Re: Written Ex Parte Presentation in ET Docket No. 98-153

Comments on XtremeSpectrum, Inc. "Emission Mask" Proposal to the FCC

Dr. A. J. Van Dierendonck, AJ Systems
On behalf of the U.S. GPS Industry Council

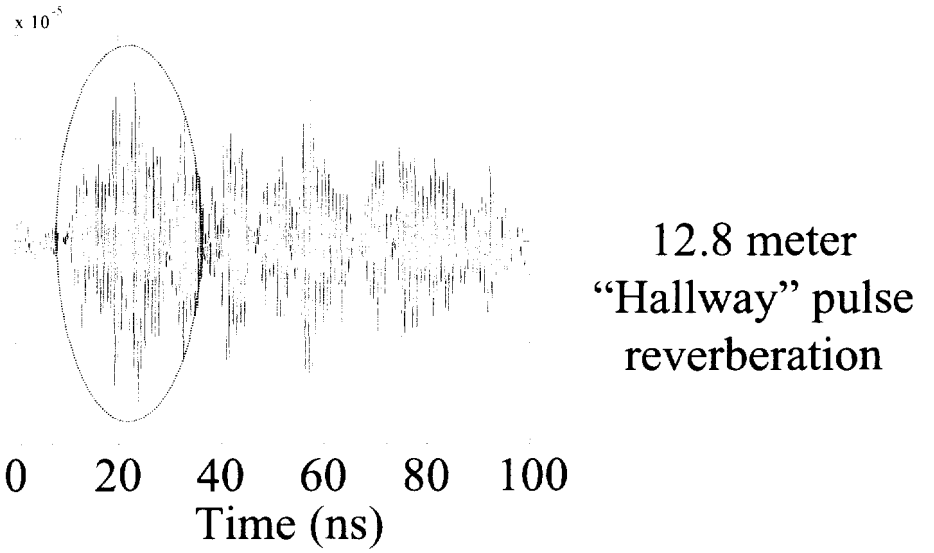
Indoors, the communications channel can exhibit extreme amounts of multipath (reverberation) as shown in the following typical pulse response down a hallway (2.0

nanosecond UWB burst at 1.5 GHz center frequency). Thus, one cannot assume that, even without GPS filtering, UWB pulses remain distinct and non-overlapping, especially with multiple emitters.
